Assessment Officer Report

PA2503651 1061 Mountain
Highway, Boronia

Officer Assessment Report
Development Assessment

Figure 7: Southern setback to Mountain Highway

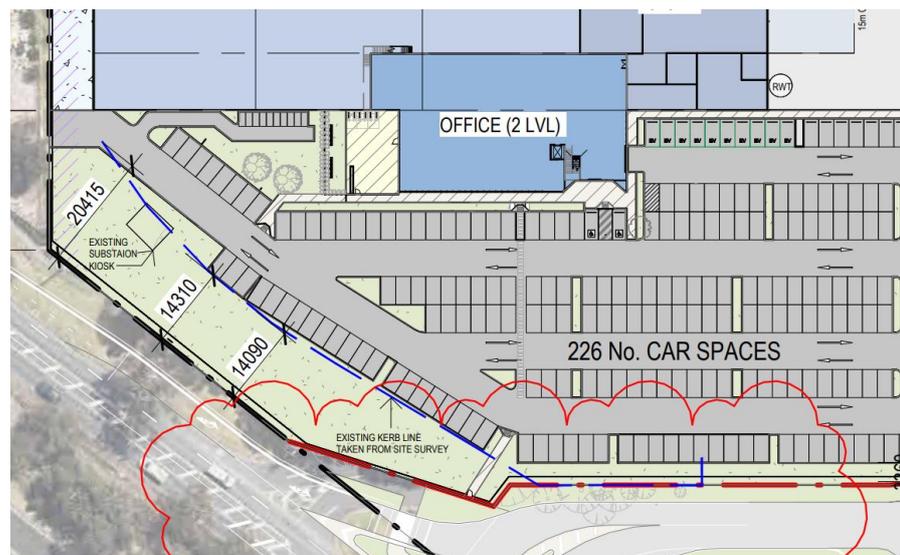
- Council raised concerns with the proposed southern setback, noting that Clause 15.01-1L seeks to provide a minimum 20m setback from all TR22 roads. The proposal has been setback 20m to the east of the intersection, however a variation is sought to the west of the intersection where the proposal is setback 14.31m from Mountain Highway. The variation is considered acceptable noting that this is an existing condition (as per Figure 7) and only occurs for a small portion of the frontage. In addition, it is noted that a number of other sites along Mountain Highway include carparking areas encroaching within the 20 metre setback, including at 1019 Mountain Highway, 1003-1005 Mountain Highway, and 999 Mountain Highway, among others.
